Transmitter Characteristics (83D.3.1)

Ryan Latchman, Mindspeed

Transmit equalization characterization

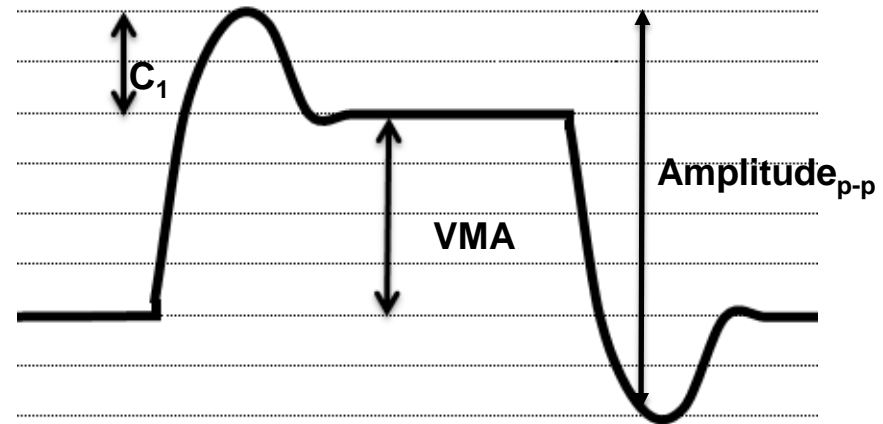
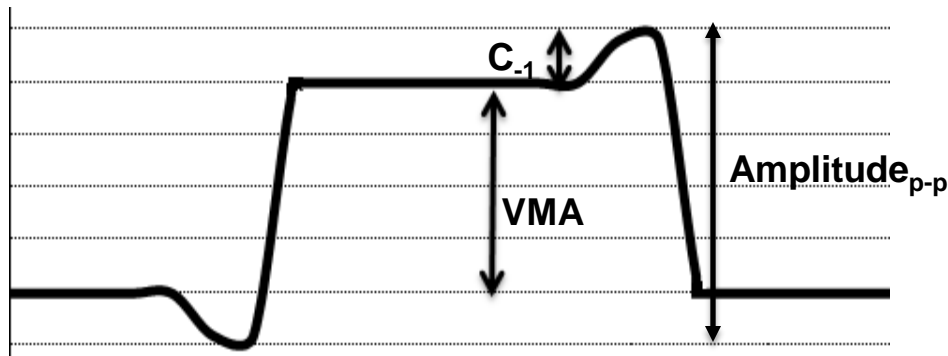
**Minimum transmit equalizer range:
Change TBD to tables shown on right**

- **Transmitter equalizer range**
- The CAUI-4 chip-to-chip transmitter includes programmable equalization to compensate for the frequency-dependent loss of the channel and to facilitate data recovery at the receiver. The functional model for the transmit equalizer is the three tap transversal filter shown in TBD. The minimum pre cursor equalization (c(-1)) supported is shown in table TBD.

- The minimum post cursor equalization (c(1)) support is shown in table TBD

- The transmitter output equalization is characterized using the procedure described in TBD.

Pre Cursor Equalizer Setting	Pre Cursor Equalization Value
1	0dB +/- 1dB
2	1.5dB +/- 1dB
3	3dB +/- 1dB

Post Cursor Equalizer Setting	Post Cursor Equalization Value
1	0dB +/- 1dB
2	2dB +/- 1dB
3	4dB +/- 1dB
4	6dB +/- 1dB

- Measure VMA per 86A.5.3.5 using square wave or PRBS9 defined in Table 86-11 using a test system with a fourth-order Bessel-Thomson low-pass response with 33 GHz 3 dB bandwidth
- Set post-cursor equalization to the zero setting. Measure pre-cursor amplitude defined as the peak amplitude before a transition. Define C_0 , C_{-1} as normalized main tap, and pre-cursor values per equations A and B. Calculate pre-cursor value for each pre-cursor setting using equation C
- Set pre cursor equalization to the zero setting. Measure post-cursor amplitude defined as the peak amplitude after a transition. Define C_0 , C_1 as normalized main tap, and post-cursor values per equations D and E. Calculate post-cursor value for each post-cursor setting using equation F

Figure 83D-7—Transmitter eye mask

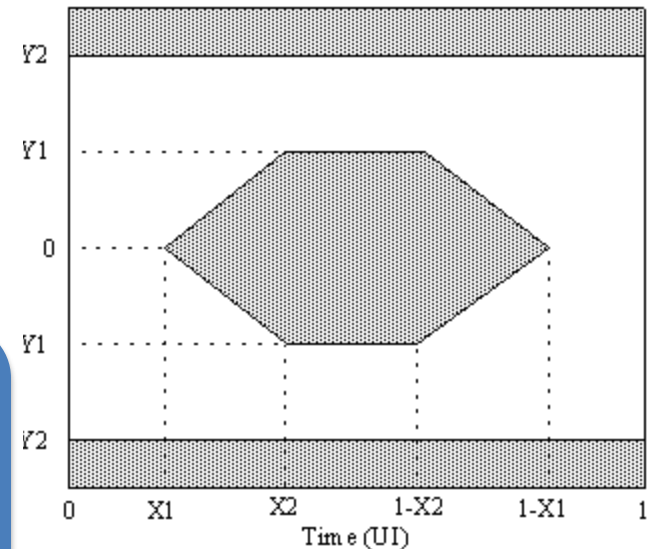
Measurement Methodology for Eye Mask – Leverage 83E

- The eye mask shown in is defined at a BER of 10^{-15} , using the methodology described in TBD. Transmitter equalizer may be adjusted for optimum mask results.

- The transmit output waveform in CAUI-4 chip-to-chip is measured using a fourth-order Bessel-Thomson low-pass filter response with 33 GHz 3 dB bandwidth. Compliance with X1 is verified using the methodology described in 83D.3.1.4 where the maximum TJ is $2 \times X1$. Compliance with Y2 is verified using the methodology described in 83D.3.1.1. Compliance with Y1 is verified using the following procedure with a PRBS9 waveform:

- Capture the PRBS9 pattern using a clock recovery unit with 3 dB tracking bandwidth of 10 MHz and maximum peaking of 0.1 dB and a minimum sampling rate of 3 samples per bit. Collect sufficient samples equivalent to at least 4 million bits to allow for construction of a normalized cumulative distribution function (CDF) to a probability of 10^{-6} without extrapolation.

- Use the differential signal from step 1 to construct the CDF of the signal amplitude at X2, midpoint (0.5) and $1-X2$, for both logic 1 (CDF1) and logic 0 (CDF0), as a distance from the center of the eye. Calculate the eye height for each point (EH6) as the difference in amplitude between CDF1 and CDF0 with a value of 10^{-6} . CDF0 and CDF1 are calculated as the cumulative sum of histograms of the amplitude at the top and bottom of the eye normalized by the total number of sampled bits. For a well balanced number of ones and zeros the maximum value for CDF0 and CDF1 will be 0.5.

- Apply the Dual-Dirac and tail fitting techniques to CDF1 and CDF0 to estimate the noise at X2, 0.5 and $1-X2$ points. Calculate the best linear fit in Q-scale over the range of probabilities of 10^{-4} and 10^{-6} of CDF1 and CDF0 to yield relative noise one (RN1) and relative noise zero (RN0). The eye height for plotting against the eye mask at X2, 0.5, and $1-X2$ is then given by

- $EH15 = EH6 - 3.19 \times (RN0 + RN1)$
- where
 - *EH15 peak* is the eye height extrapolated to 10^{-15} probability
 - *EH6* is the eye height at 10^{-6} probability
